## STAFF REPORT

### Community Planning and Preservation Commission Certificate of Appropriateness Request

<b>Case No.:</b>	<b>21-90200104</b>
Address:	3327 6 <sup>th</sup> Avenue North
Legal Description:	KENWOOD SUB ADD BLK 21, LOT 11
Parcel ID No.:	14-31-16-46350-021-0110
Date of Construction:	1940
Local Landmark:	Kenwood Section – Northwest Kenwood Local Historic District (18-90300008) – Contributing Property
Owner:	Nicole Mayne

Agent: Boyle's Aluminum and Screening  
 Request: Review of a Certificate of Appropriateness for the construction of a screened in, covered patio addition on the rear of 3327 6<sup>th</sup> Avenue North, a contributing structure to a local historic district.  
 Zoning: Neighborhood Traditional-2 (NT-2)

Figure 2: Proposed rear, screened in patio. The patio roof will be installed below the drip edge on the main roof structure.

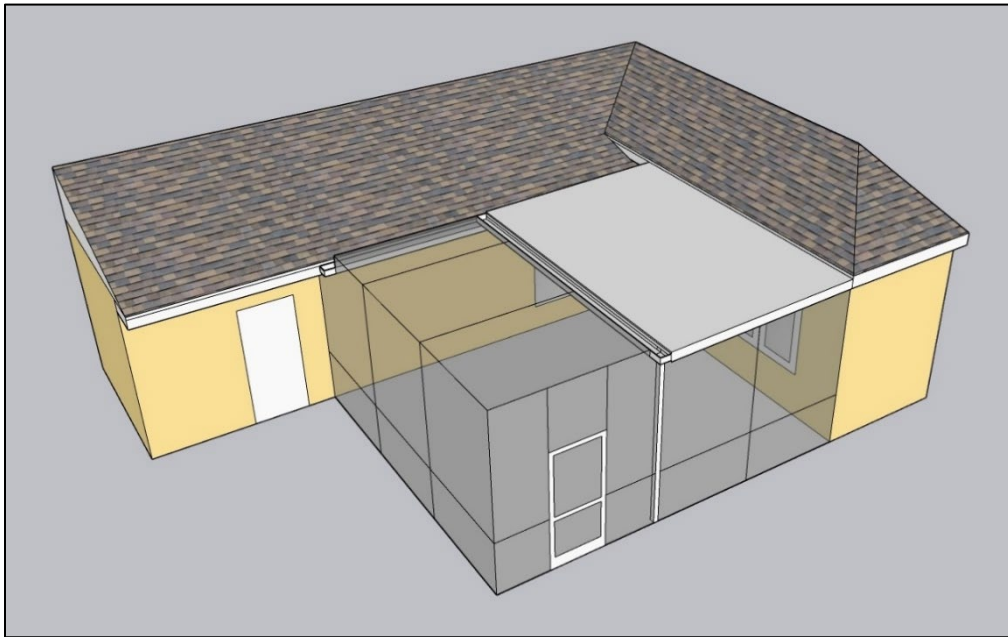
**Consistent** The proposed rear patio will be approximately 360 square feet, and the height of the roof will be lower than the principal structure. The patio will utilize a simple, flat roof form. The proposed patio addition will be nine feet tall and will have minimal impact on the contributing resources in the district.

**Inconsistent** The application proposes an aluminum structure, which is not a traditional construction method.

**Consistent** The proposed roof will be nearly flat with a slight slope. Shed, gabled, or hipped roofs were more commonly constructed during the historic era, but flatter roofs were sometimes used, particularly for mid-century additions.

Based on a determination of general consistency with Chapter 16, City Code of Ordinances, staff recommends that the Community Planning and Preservation Commission **approve** the Certificate of Appropriateness request for the alteration of the property at 3327 6<sup>th</sup> Avenue North, a contributing property to the Northwest Kenwood Local Historic District, with the following conditions:

1. A historic preservation final inspection will be required.
2. All other necessary permits shall be obtained. Any additional work shall be presented to staff for determination of the necessity of additional COA approval.
3. This approval will be valid for 24 months from the date of this hearing, with an expiration date of November 8, 2023.

Figure 3: Survey with proposed addition located in the yellow highlighted portion.

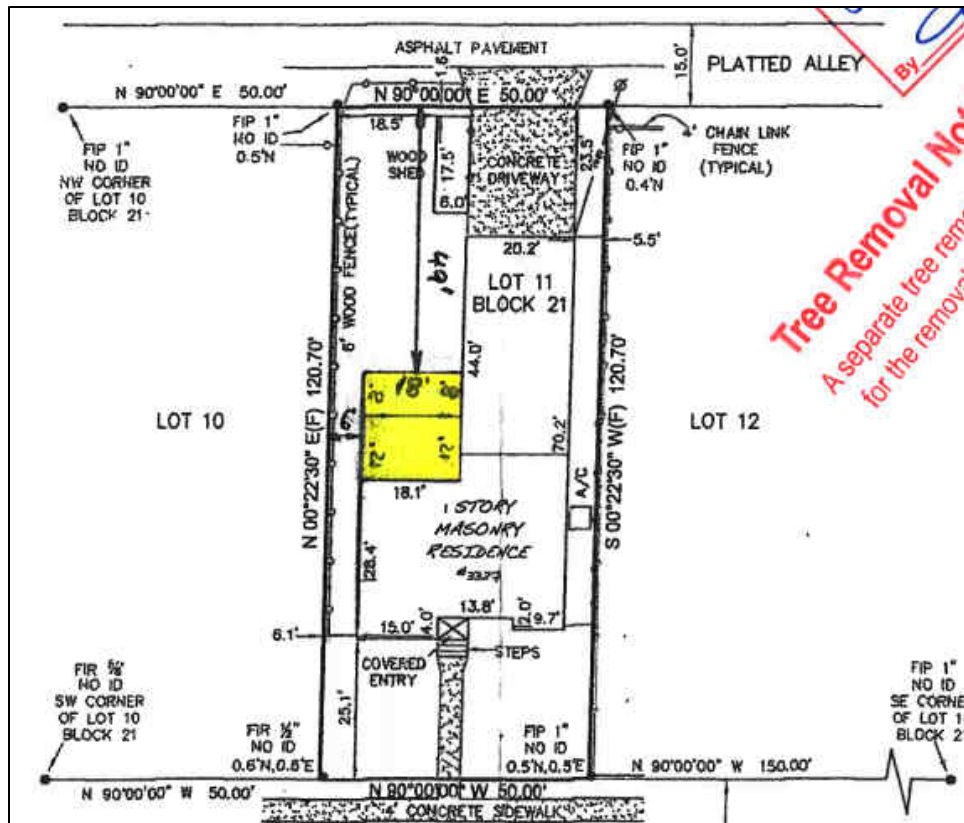
**Consistent**      The project proposes a patio addition to the interior rear yard, minimizing the impact to the district.
2. *The relationship between such work and other structures on the landmark site or other property in the historic district.*

**Consistent** The proposed porch will be located on an existing deck and in an interior rear yard.
